Regarding: FCC Class II Permissive Change  
FCC ID: 2AVNR-RPI3BP

We, Noiseless Acoustics Ltd. hereby declare that the intention of this Class II Permissive Change is to change the grant from mobile module to portable module in order to authorize the module for use in a handheld device. We have done some hardware modifications to the module for integration purposes, although, they do not involve the RF circuitry.

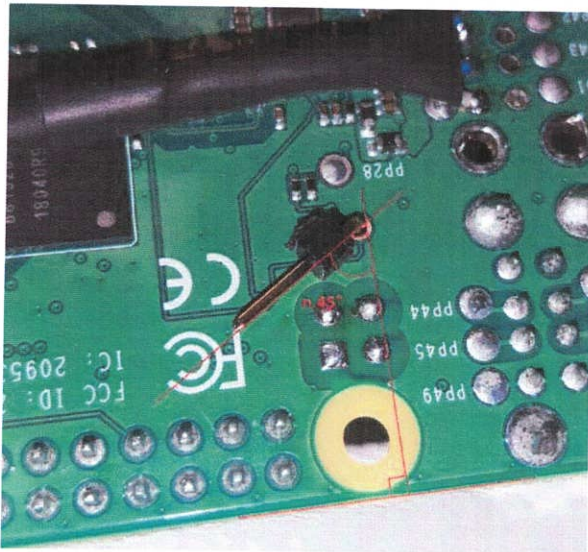
- 2. added cable to the pads of the connector J11

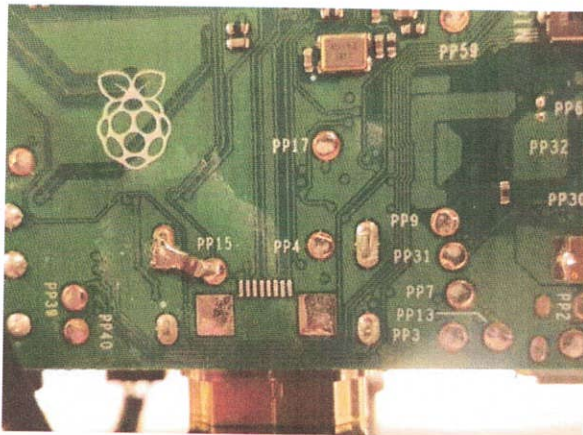
- 3. added header for the RUN-signal to its designated place

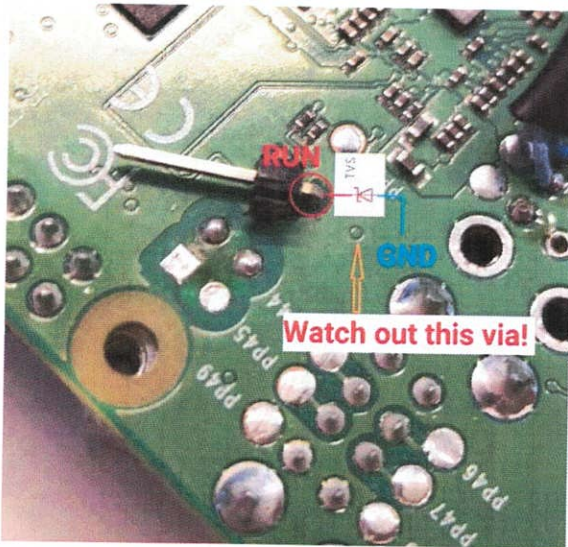
- 4. added signal protection components to RUN signal.

The capacitor will be soldered to PP15 and GROUND-pin nearby

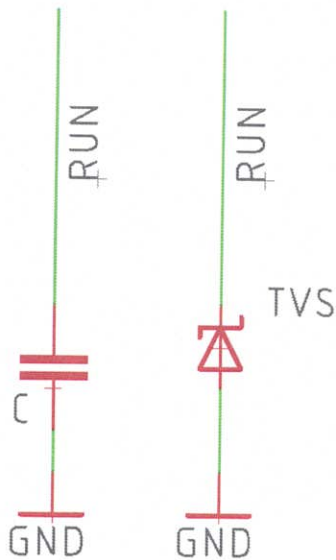
The placement of the TVS diode nearby the pin header

The schematics of the signal protection components of the run signal.
